Access Compliance Report Public Rights-of-Way (Curb Ramps)

Main Street: KYLE_CT Cross Street: KYLE_CT Location: W

ADA ID: RPRK211101114810 Ramp Type: Type 4 - Parallel Initial Pass/Fail: Fail Overall Compliance: No Severity Score: 20

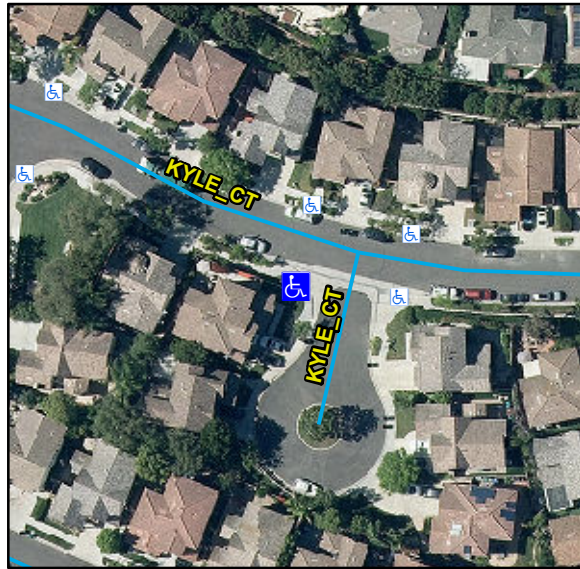
Compliance	Description	Data	Compliance	Description	Data
N/A	Ramp Length LT (in)	116	N/A	Ramp Length RT (in)	115
Yes	Ramp Width LT (in)	54	No	Ramp Width RT (in)	44
Yes	Ramp Run Slope LT (%)	3.4	No	Ramp Run Slope RT (%)	9.9
No	Ramp Cross Slope LT (%)	2.6	Yes	Ramp Cross Slope RT (%)	1.3
N/A	Landing Present	N/A	N/A	DWS Provided	N/A
N/A	Landing Length (in)	N/A	N/A	DWS Contrast	N/A
N/A	Landing Width (in)	N/A	N/A	DWS Length (in)	N/A
N/A	Landing Run Slope (%)	N/A	N/A	DWS Full Width	N/A
N/A	Landing Cross Slope (%)	N/A		DWS Offset Type	N/A
N/A	Landing Movement Obstructed?	N/A	N/A	DWS Offset Left (in)	N/A
	Landing Movement Type	N/A	N/A	DWS Offset Right (in)	N/A
N/A	Landing Shared	N/A			
N/A	Clear Space	Yes			
N/A	Clear Space To Crosswalk (in)	N/A			
N/A	Marked Crosswalk 1	No	N/A	Marked Crosswalk 2	No
	Crossing 1 Direction	SE		Crossing 2 Direction	NE
N/A	Marked Crosswalk 1 Width (in)	N/A		Marked Crosswalk 2 Width (in)	N/A

Remove & Replace Curb Ramp With Two New Directional Ramps or Equivalent.

R304.5.1, R304.5.3, R304.3.2, STD 1115
